<b>Docket Number:</b>	16-EPIC-01
<b>Project Title:</b>	EPIC Idea Exchange
<b>TN #:</b>	221630
<b>Document Title:</b>	Andy Kruse Comments feedback on the CEC microgrid roadmap
<b>Description:</b>	N/A
<b>Filer:</b>	System
<b>Organization:</b>	Andy Kruse
<b>Submitter Role:</b>	Public
<b>Submission Date:</b>	10/26/2017 8:42:08 AM
<b>Docketed Date:</b>	10/26/2017

## **feedback on the CEC microgrid roadmap**

# ROADMAP FOR COMMERCIALIZING MICROGRIDS IN CALIFORNIA

**Figure 2: The Duck Curve**

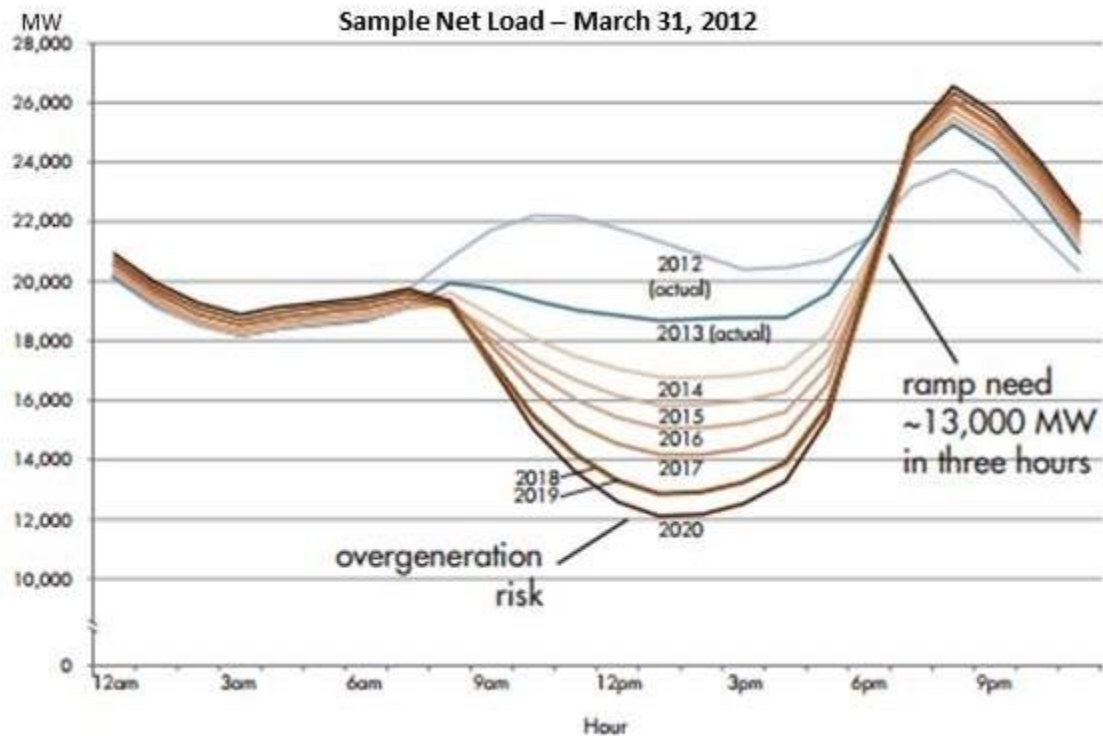
I would also suggest including a discussion on the impact of IoT/demand response on the grid and its potential impact. The more demand response is implemented the greater impact on the Duck-Curve.
